APPROVED
By Andrew McCreight at 8:41 am, Apr 04, 2023

DENTECH HOLDINGS INC
PROPOSED APARTMENT
797 RICHMOND ROAD
CITY OF OTTAWA
SITE SERVICING PLAN

Anley GROUP CONSULTING ENGINEERS PLANNERS
CONTRACT No. 21006 004-21006-S1

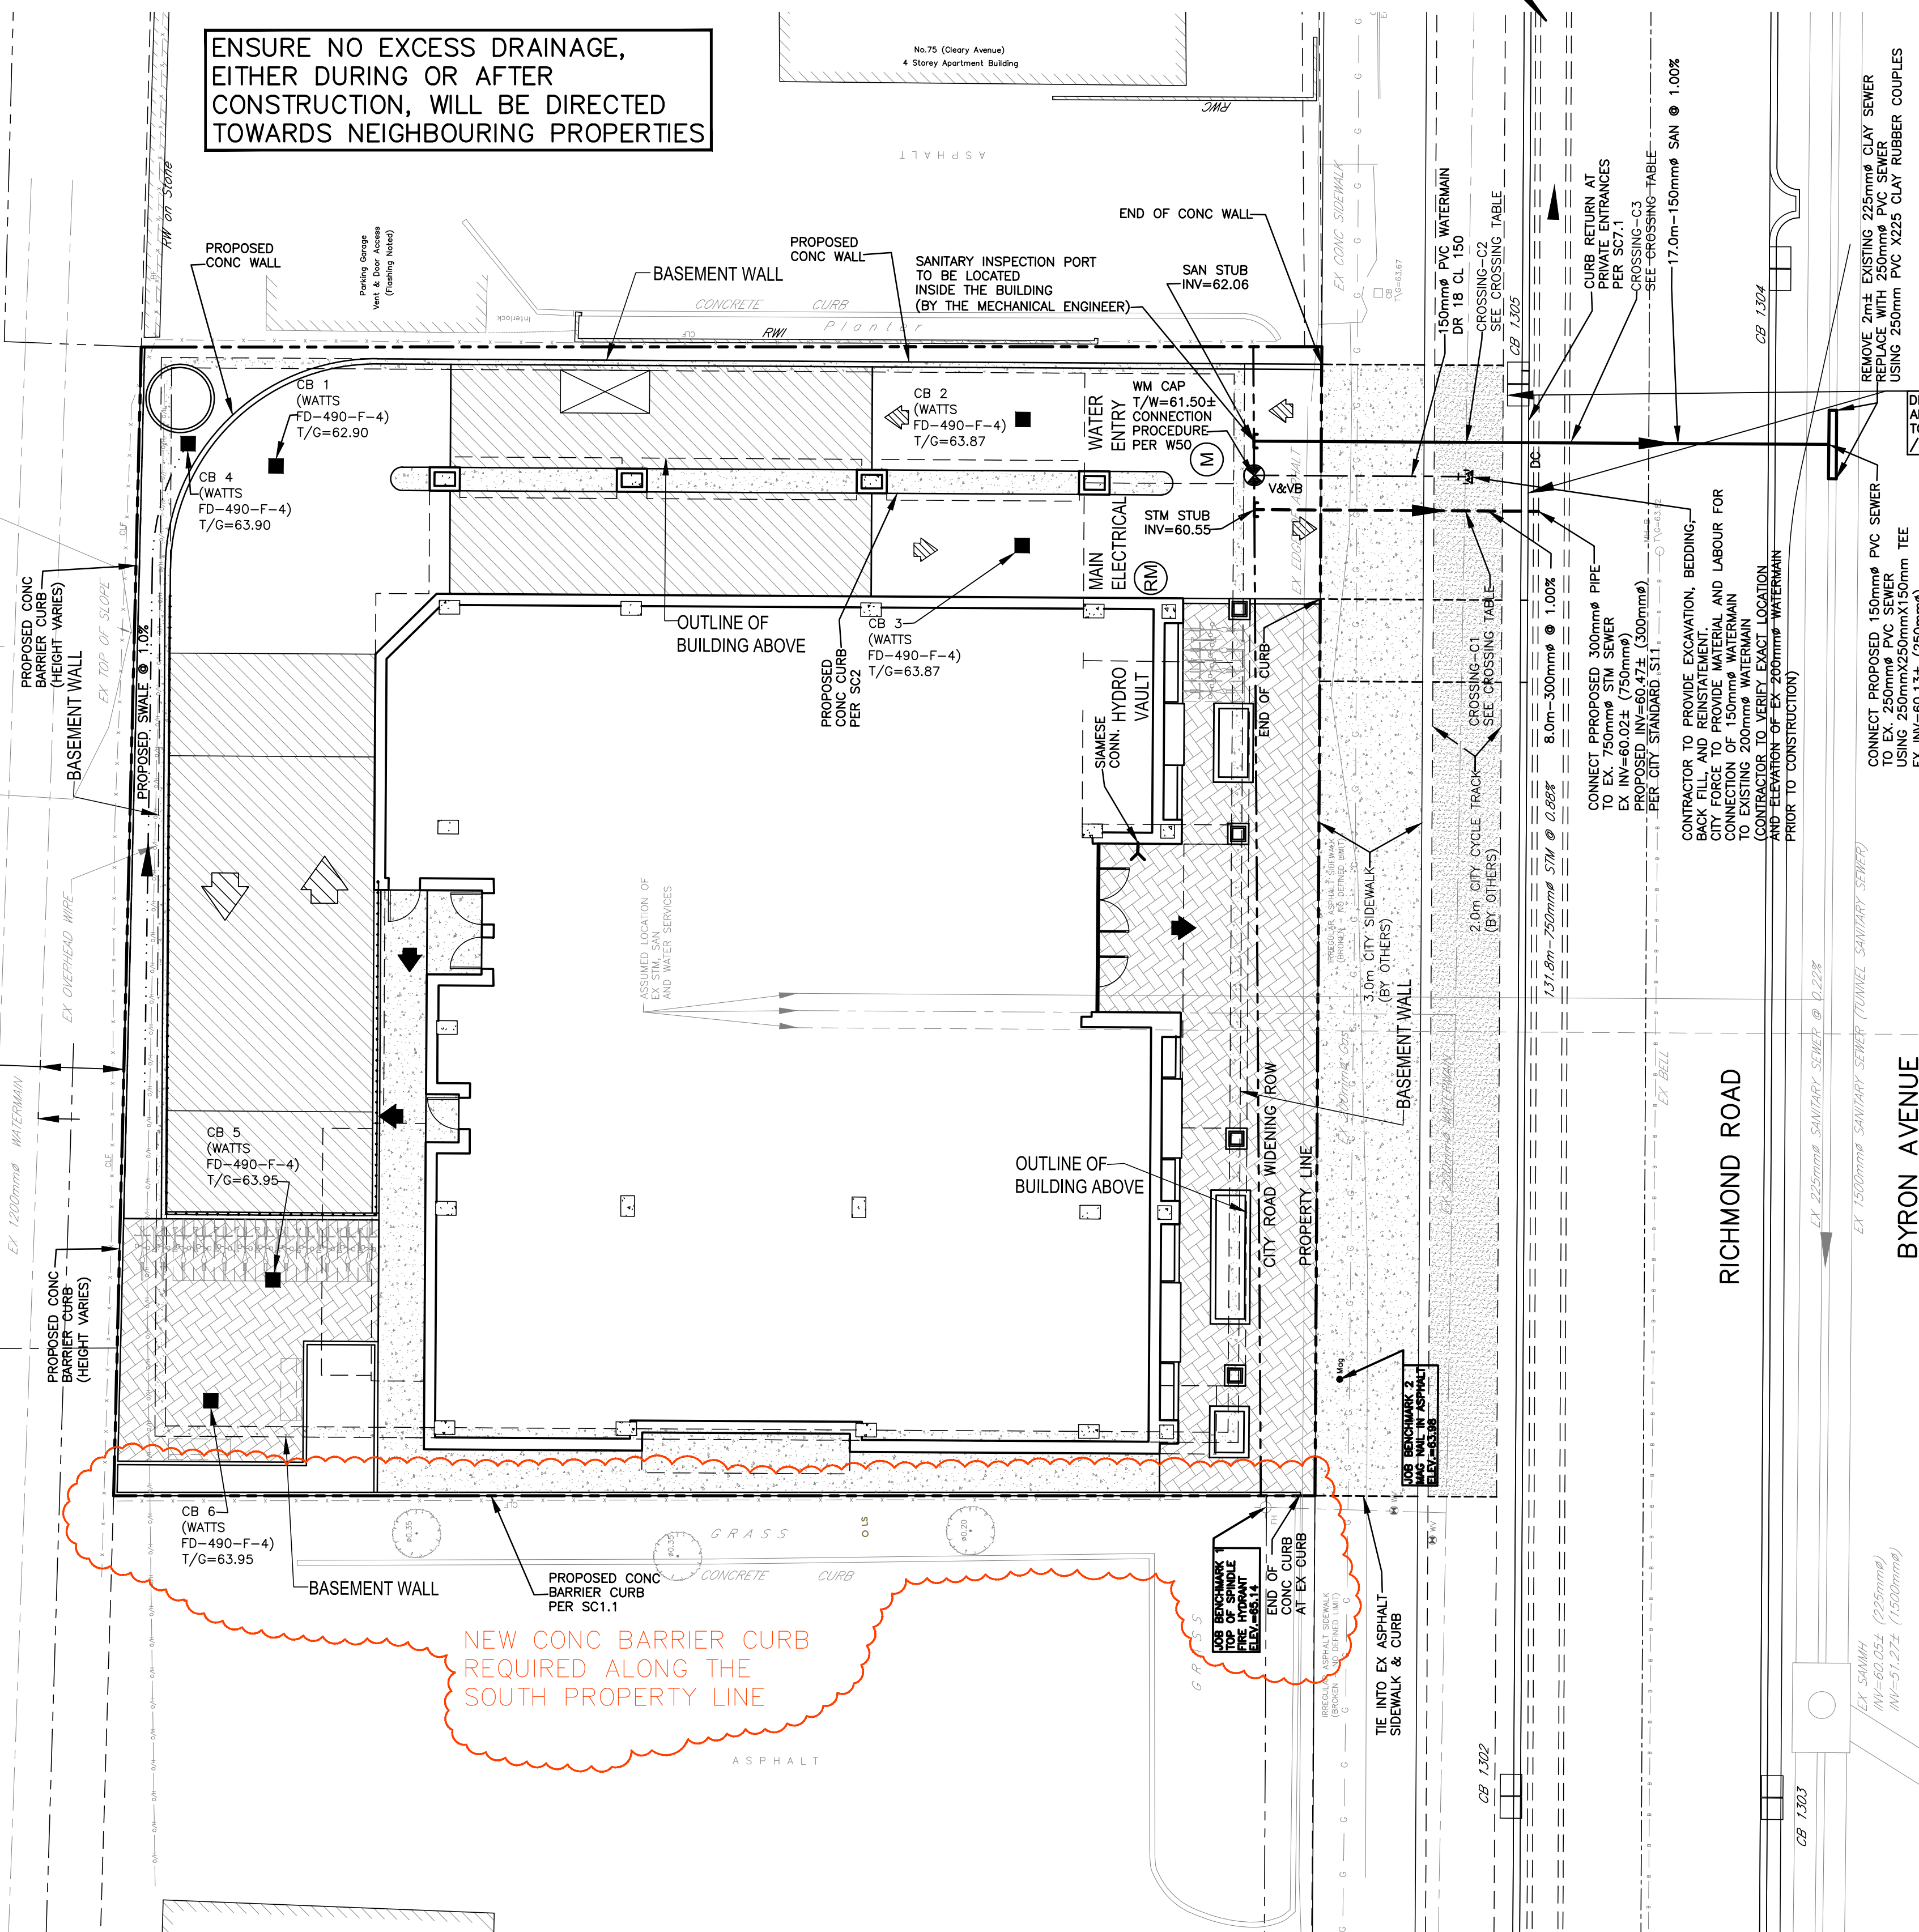
ENSURE NO EXCESS DRAINAGE, EITHER DURING OR AFTER CONSTRUCTION, WILL BE DIRECTED TOWARDS NEIGHBOURING PROPERTIES

NEW CONC BARRIER CURB REQUIRED ALONG THE SOUTH PROPERTY LINE
